The Texas Commission on Environmental Quality (TCEQ, agency, or commission) proposes the repeal of §§217.1, 217.36, 217.63, 217.69, 217.70, 217.94, 217.162, and 217.193; new §§217.1, 217.18, 217.36, 217.40, 217.63, 217.69 - 217.71, 217.90, 217.94, 217.120, 217.162, 217.193, and 217.194; and amendments to §§217.2 - 217.17, 217.31 - 217.35, 217.37 - 217.39, 217.51 - 217.62, 217.64 - 217.68, 217.91 - 217.93, 217.95 - 217.100, 217.121 - 217.129, 217.151 - 217.161, 217.163, 217.164, 217.182 - 217.192, 217.201 - 217.213, 217.241 - 217.252, 217.271 - 217.283, 217.291 - 217.300, 217.321 - 217.330, 217.332, and 217.333.

Background and Summary of the Factual Basis for the Proposed Rules

Figure: 30 TAC §217.278(c)(3)

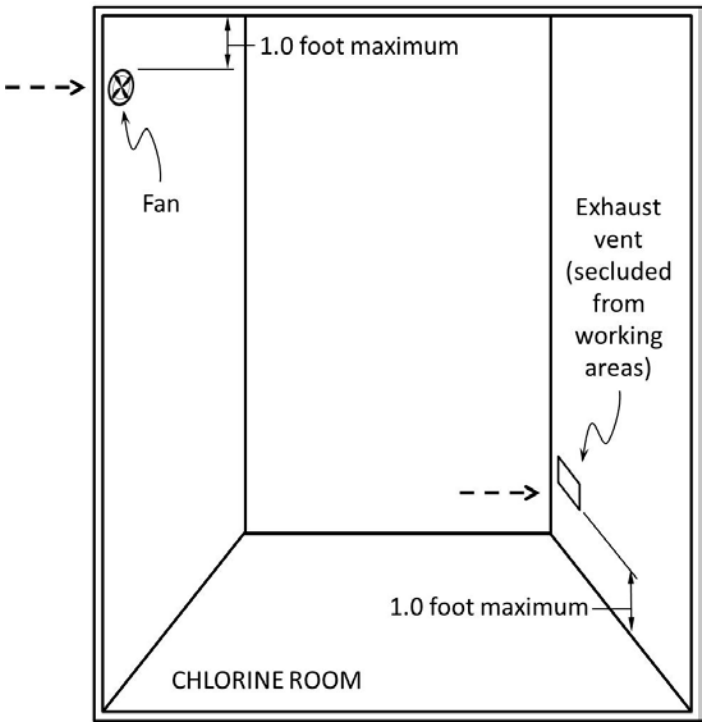
(3) A fan must be located at the top of the room to push air across the room and through an exhaust vent located at the bottom of the room on the opposite side (see Figure: 30 TAC §217.278(c)(3)). The top of the fan must be no more than one foot below the ceiling. The bottom of the exhaust vent must be no more than one foot above floor level.
